STAFF REPORT
COMMUNITY DEVELOPMENT DEPARTMENT

SUBJECT: FP-2022-0026
Gander Creek South Subdivision No. 3

Final plat consisting of 75 single family residential building lots and 10 common lots on 13.77 acres of land in the R-8 zoning district for Gander Creek South No. 3.

NOTE:
SEE SHEET 4 OF 6
FOR LINE & CURVE
TABLES
SHEET 1 OF 6

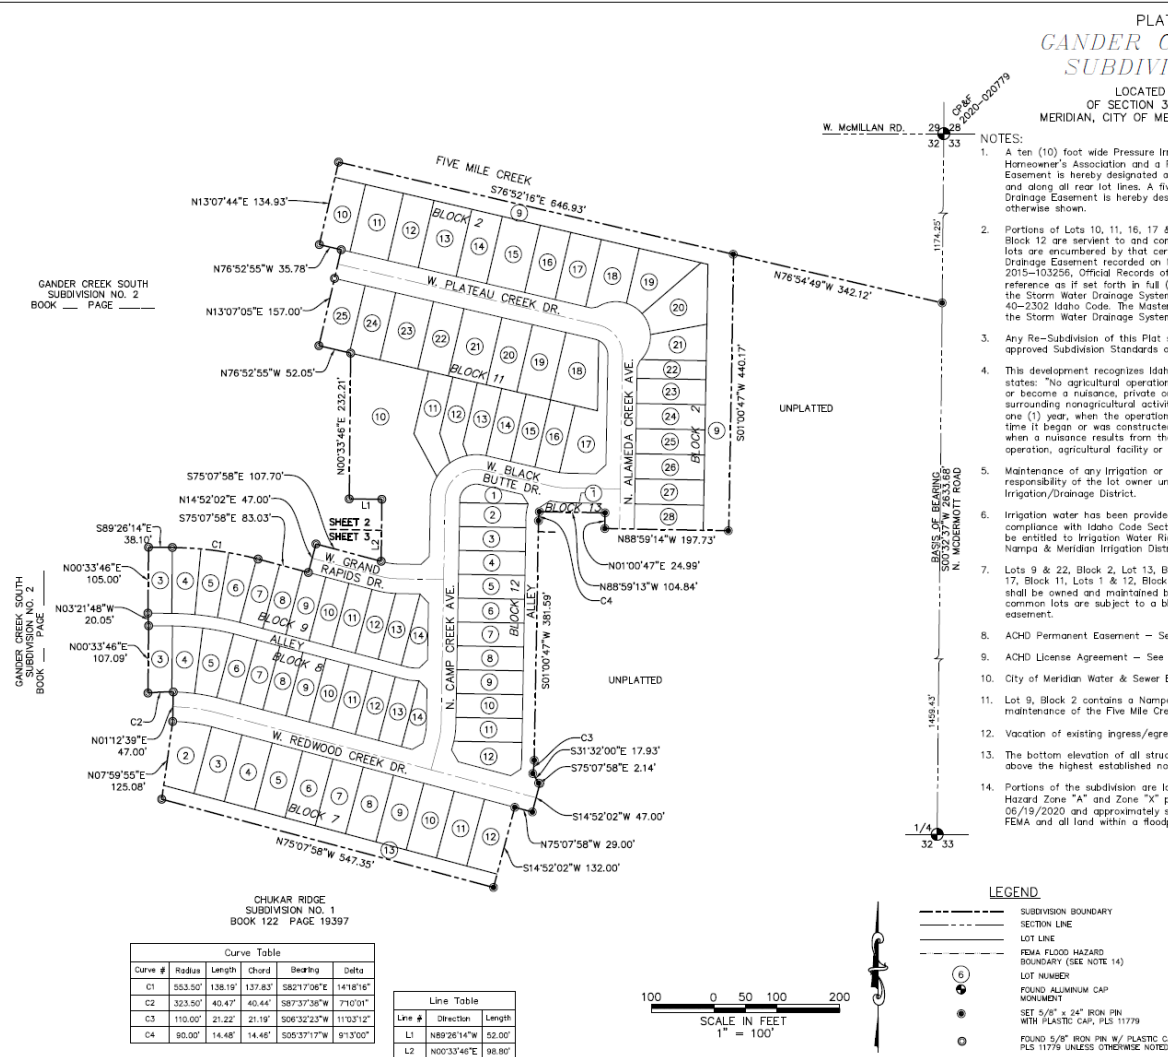
- a. Note #8: Include the recorded Instrument Number for the ACHD Permanent Easement.
 - b. Note #9: Include the recorded Instrument Number for the ACHD License Agreement.

- c. Note #10: Include the recorded Instrument Number for the City of Meridian Water & Sewer Easement.
 - d. Note #12: Include the recorded Instrument Number for the vacation of the existing ingress/egress easement.

- e. Revise Lot 12, Block 11 to comply with the minimum 30-foot wide street frontage requirement in UDC 11-2A-3B.1, measured as a chord measurement.
 - f. All buildable lots shall have a minimum 40-foot wide street frontage, except for properties with street frontage on cul-de-sacs or at approximately a 90-degree angle, which shall be a minimum of 30 feet, measured as a chord measurement; correct all lots that don't conform.

FINAL PLAT LANDSCAPE PLAN
GANDER CREEK SOUTH SUBDIVISION NO. 3
TRILOGY DEVELOPMENT

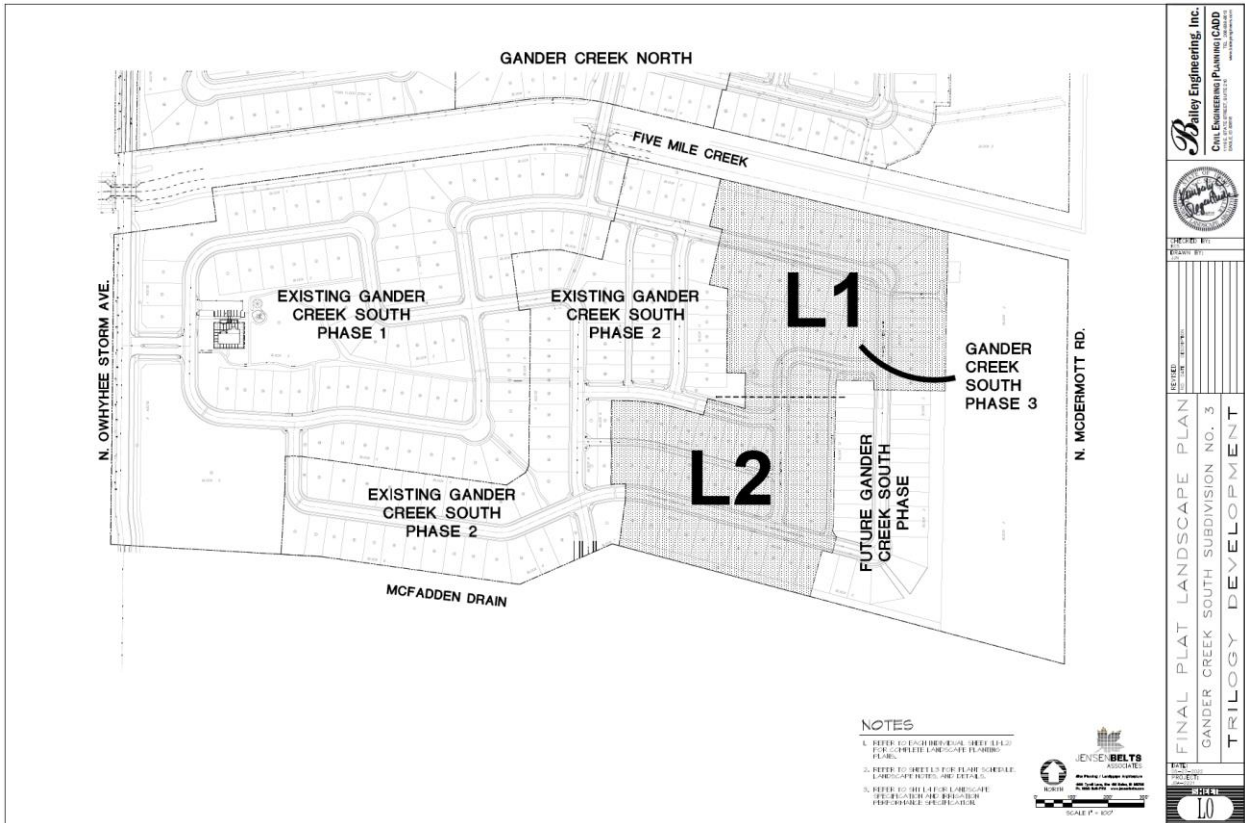
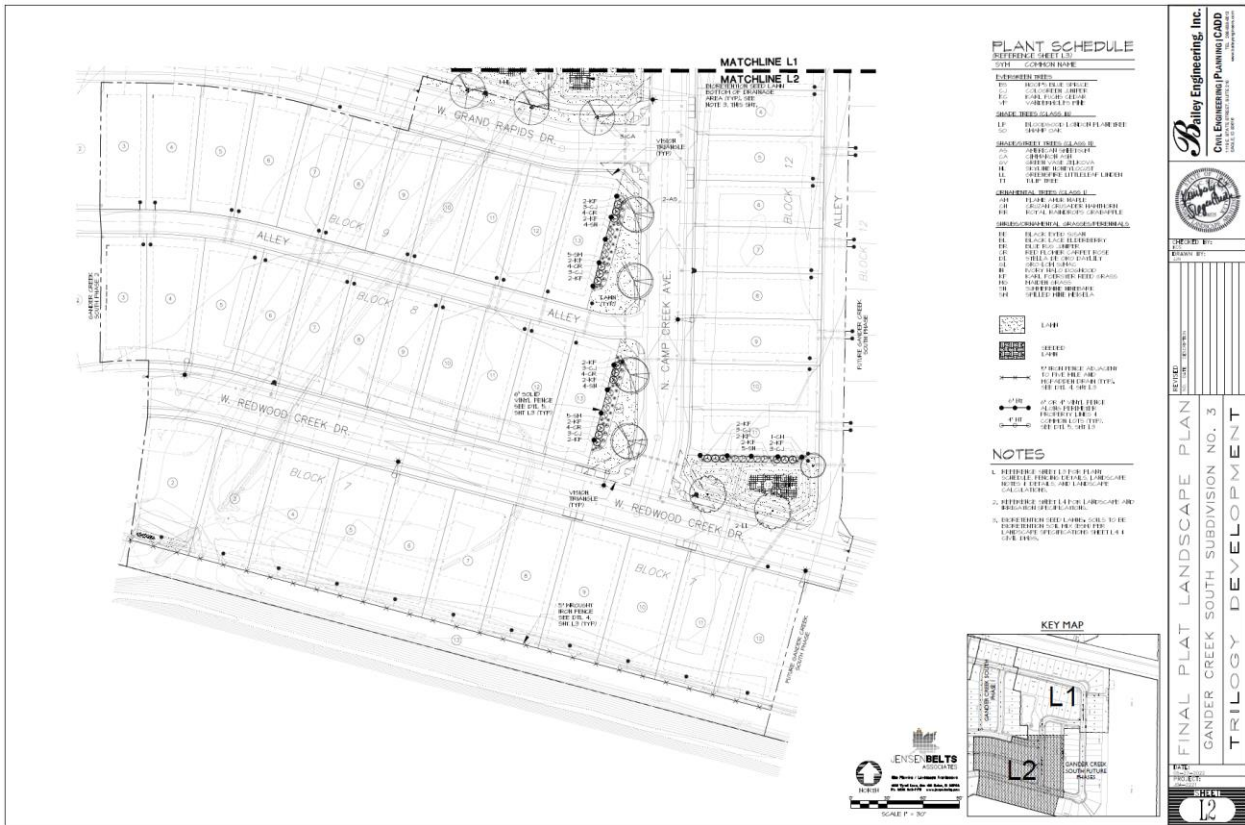
5. The landscape plan prepared by Jensen Belts Associates, dated 05/27/2022, included in Section V.C, shall be revised as follows:
 - a. In the Landscape Calculations table, include the required vs. provided number of trees along pathways that demonstrate compliance with UDC [11-3B-12C.2](#).

- b. Depict a 6-foot tall berm with a 6-foot tall wall on top of the berm as noise abatement along the east boundary of the site adjacent to future SH-16 as required by City Council at the hearing on May 28, 2019 in accord with set forth in UDC 11-3H-4D for residential uses adjoining state highways; also modify the detail for the berm. *The plan currently depicts a 4-foot tall berm with a 6-foot tall concrete wall.*

- c. A detail shall be included that depicts the centerline (or estimated centerline) of the future SH-16 in relation to the top of the berm/wall verifying it's a minimum of 12-feet higher than the elevation at the centerline of the state highway as required by UDC 11-3H-4D.2. The Director may approve alternative compliance as set forth in UDC 11-5B-5 where the Applicant has a substitute noise abatement proposal in accord with ITD standards and prepared by a qualified sound engineer as set forth in UDC 11-3H-4D.4.

- d. The 6-foot tall closed vision fence along the east boundary of the subdivision adjacent to N. McDermott Rd./future SH-16 shall be removed and either a use easement recorded across the

back side of the berm along McDermott/SH-16 benefitting adjacent building lots with allowance for side yard fences to be constructed to the wall on top of the berm; or, an open vision, 4-foot tall closed vision, or 4-foot tall closed vision with 2 foot open vision fencing on top could be constructed for visibility of the common area between the fence and wall on top of the berm.
